California Energy Commission (CEC)
Issues Hearing / Environmental Scoping Meeting
NRG Puente Project (15-AFC-01)

City of Oxnard Comments
Responding to CEC Issues Identification
of August 10, 2015

August 27, 2015

Slide 7

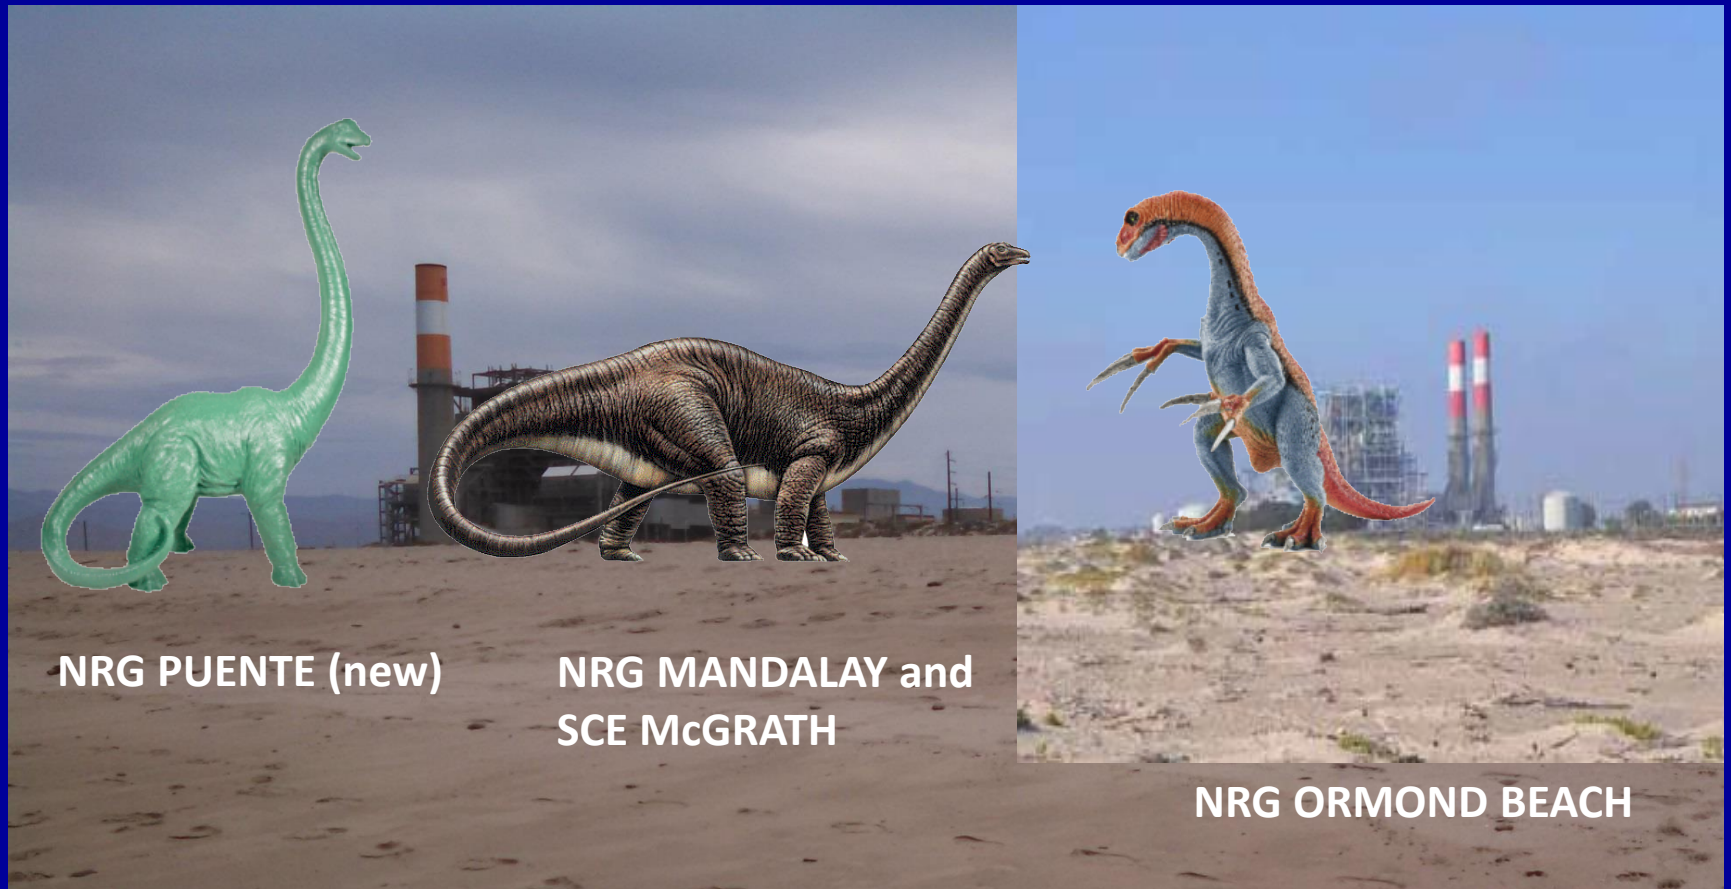
Incredibly, views and aesthetics not identified as an issue.
“Doubling” of already impacted view is doubling the impact.
“It’s already bad” suggests never trying to improve views?
NRG CEC application clearly states Mandalay remains after 2020.

If approved, Oxnard would have four beachfront power plants.

How can we ever get rid of these obsolete dinosaurs ?

Slide 10

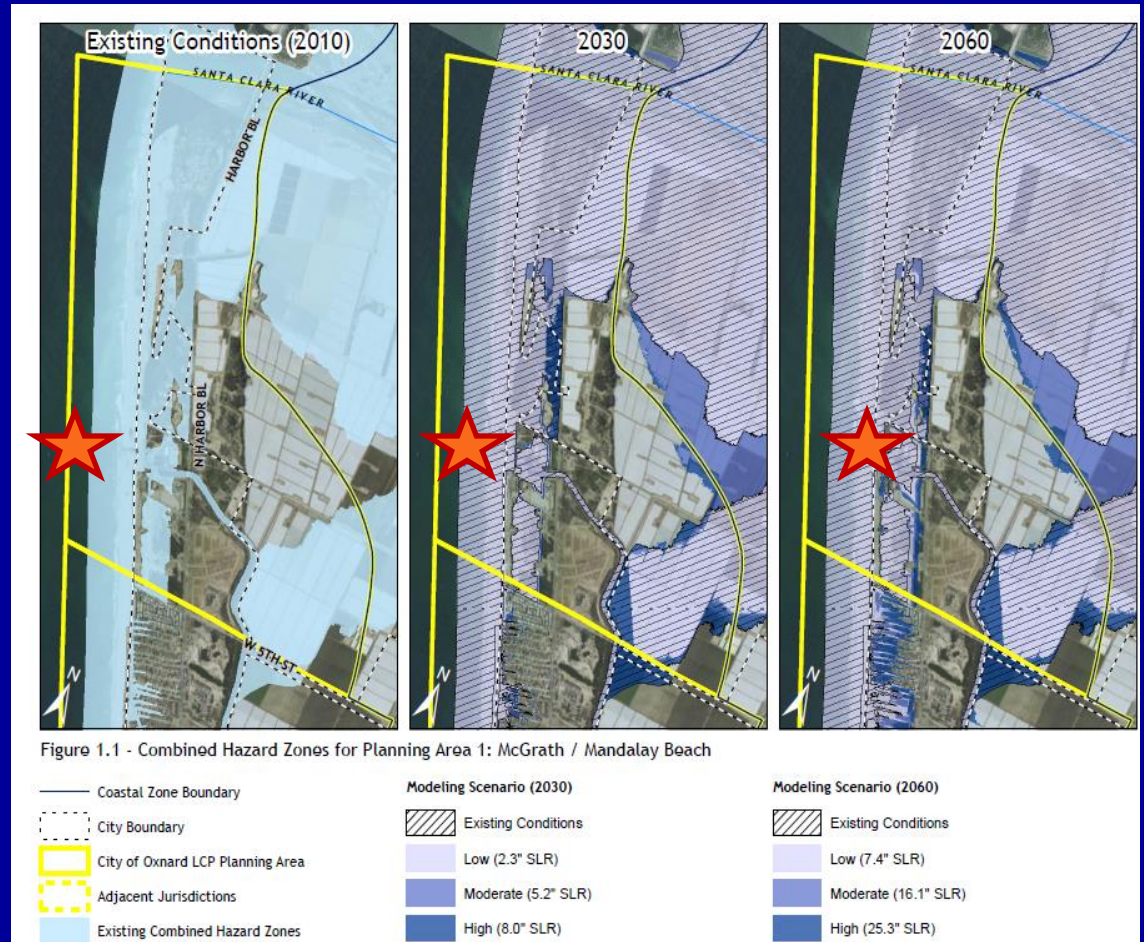
City mapping shows Harbor Blvd. flooded under existing and 2030 scenarios.

Police and Fire Departments have not completed their 30-year reviews.

Must include County Public Works, Fire, and Sheriff Departments.

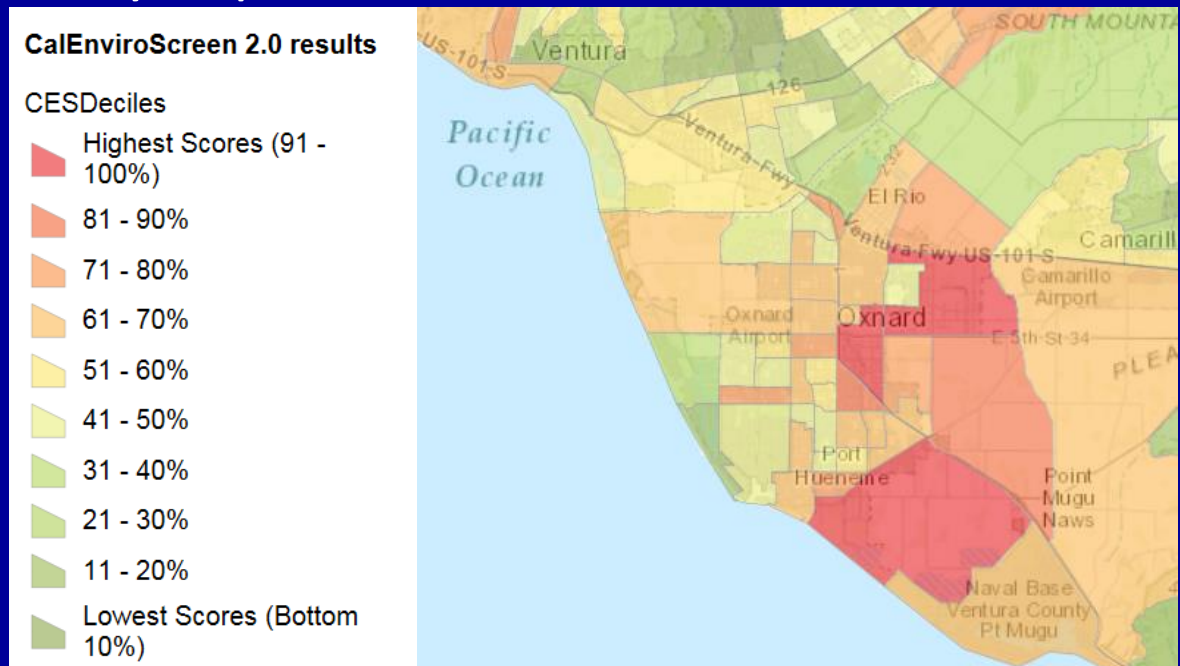
Oxnard a majority-minority community:

74% Hispanic Origin + 10% Other Non-White total = 84%

CalEnviroScreen 2.0 categorizes much of the area disadvantaged.
With three power plants, landfills, and EPA superfund site,
Oxnard is disproportionately impacted.

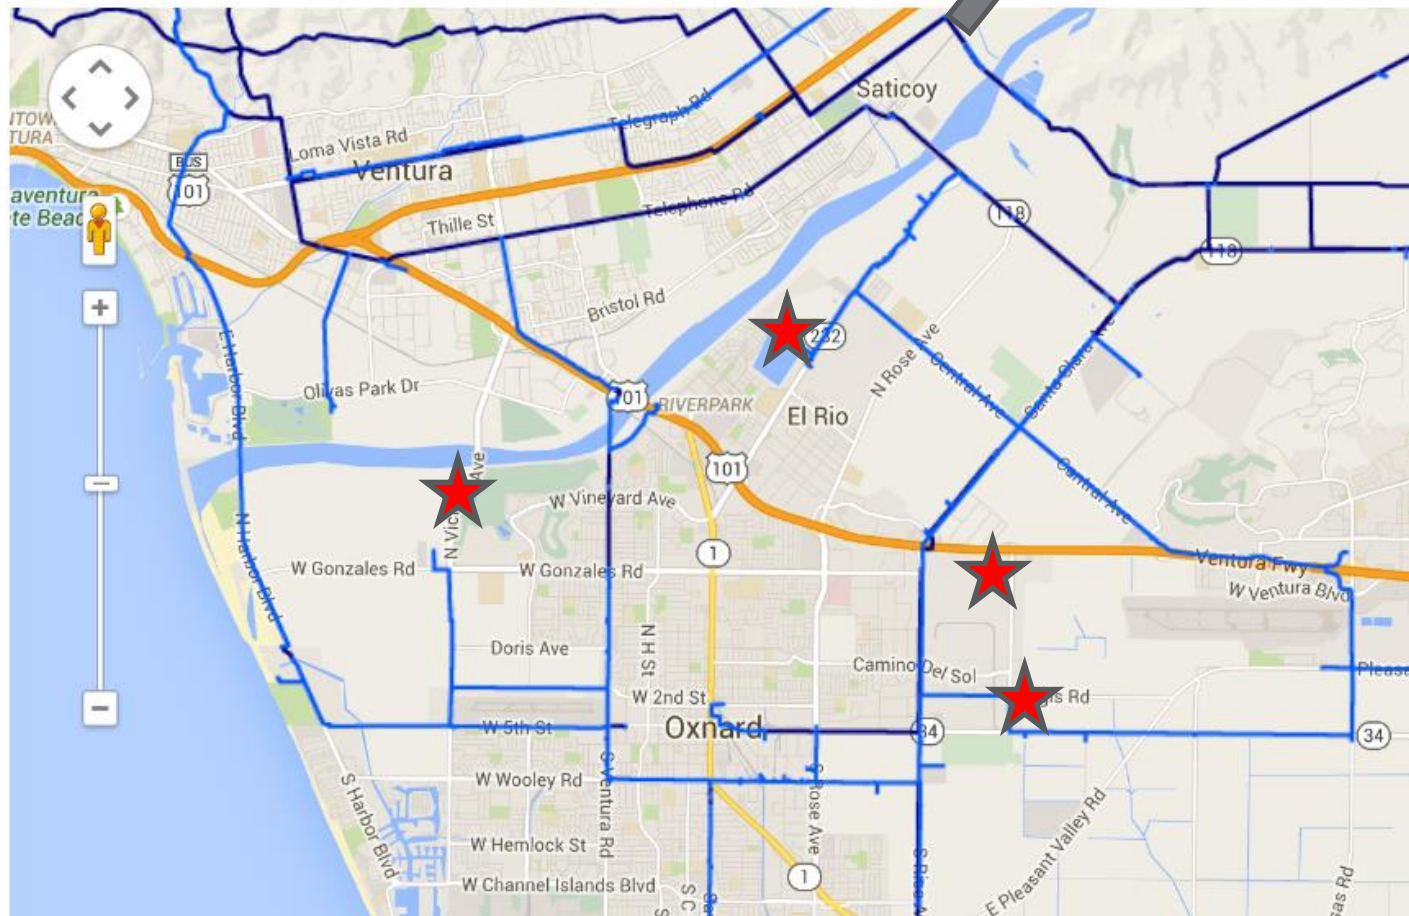
Close to high pressure gas lines and SCE transmission lines.

Two within Oxnard city limits, zoned industrial, vacant:

1. Power Machinery/Camino Avenue
2. NEC Del Norte & Fifth Street

Two could be annexed, vacant, voter approval not required:

3. Sanitation District Flower Field
4. Beedy Street

Gas Transmission and High Pressure Distribution Pipeline Interactive Map - Ventura

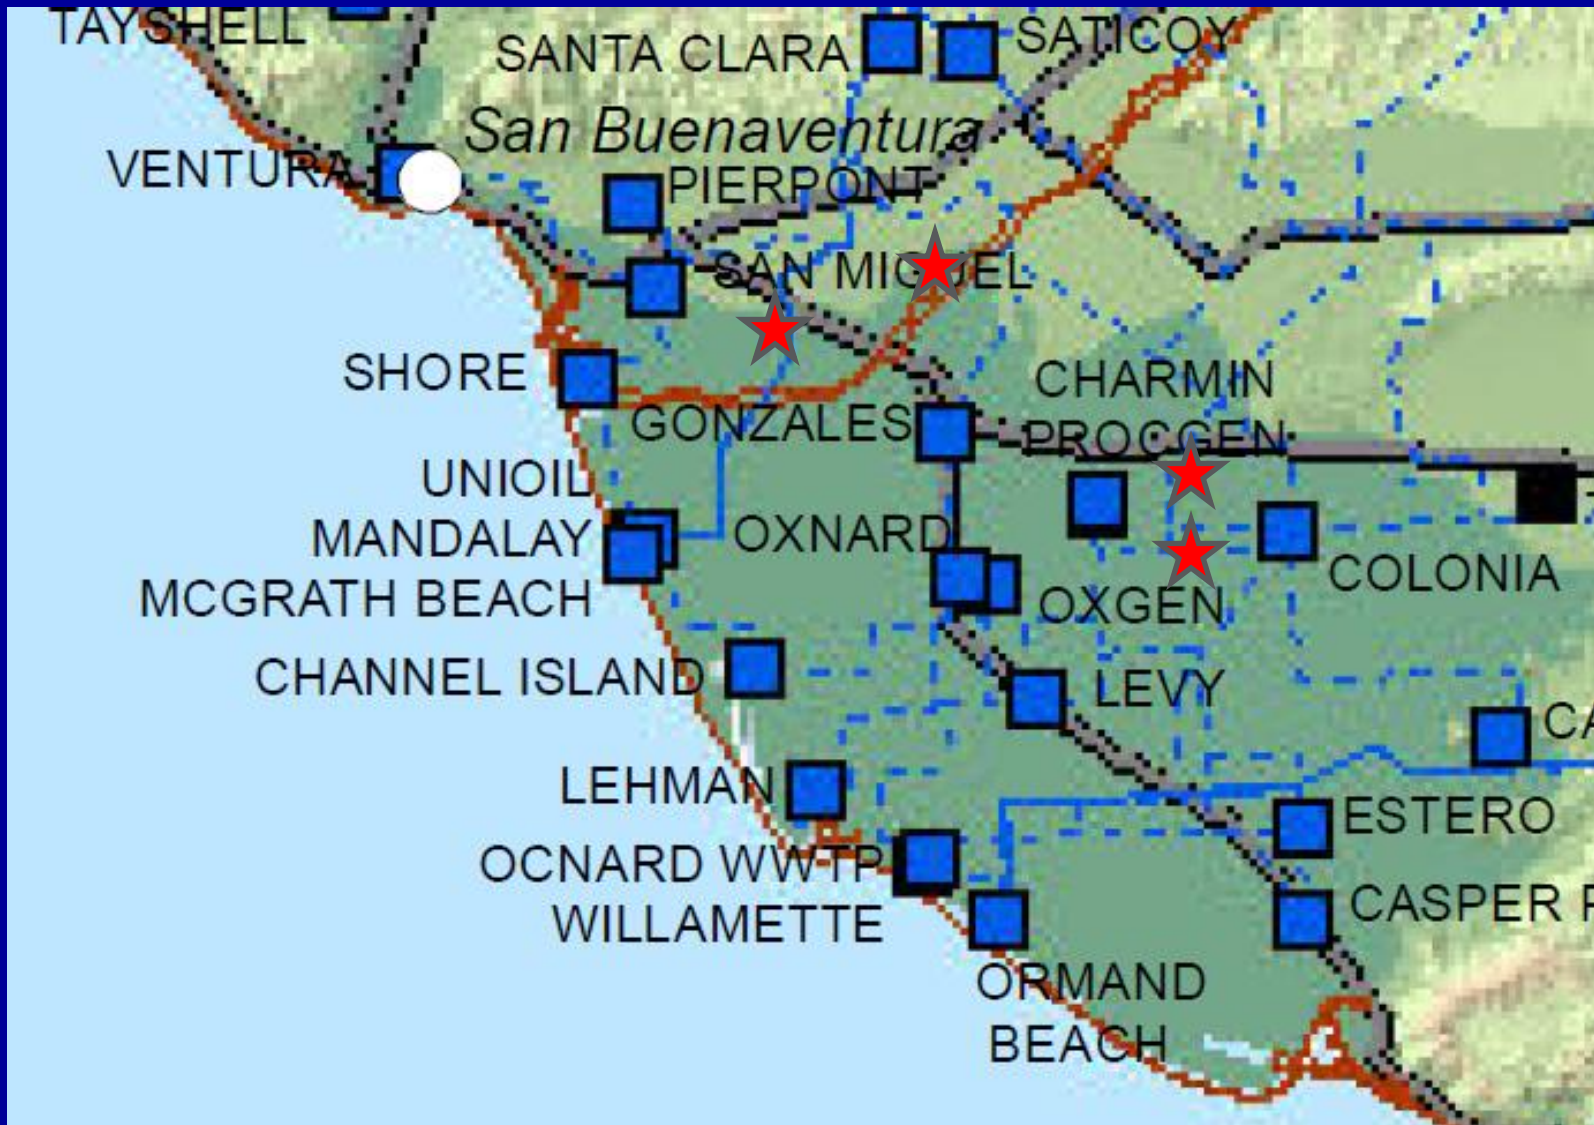
Need to be near high-pressure natural gas line
